INDESIT company

Model type:
AVSF109SITV

Commercial code:
F043598

n4008f00: Thermic link wire removed on three-phase motor

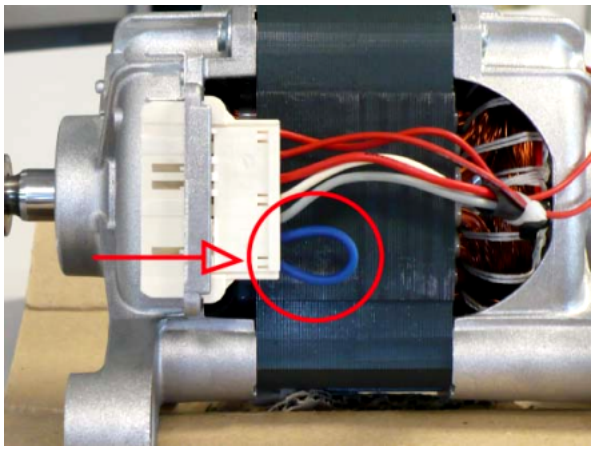
Attention!
When you assist the premodification models using the new motor code you MUST use the thermic link wire code C00265838.

The spare part warehouses will manage the premodification motor until the end of the stock, after they will be replaced with new ones and thermic link wire.

TRIPHASE P40 46 L – INOX TUB
C00265827 new motor without thermic link wire - C00116103 premodification motor with thermic link wire

TRIPHASE P40 46 L – PLASTIC TUB
C00265826 new motor without thermic link wire - C00142390 premodification motor with thermic link wire

TRIPHASE P50 52 L
C00265829 new motor without thermic link wire - C00142205 premodification motor with thermic link wire

TRIPHASE P32 46 L TOP LOADING
C00265832 new motor without thermic link wire - C00262375 premodification motor with thermic link wire

TRIPHASE P40 46 L TOP LOADING
C00265834 nuovo new motor without thermic link wire - C00112739 premodification motor with thermic link wire

In the attached image you can see the fixing of thermic link wire in the motor therminal box.
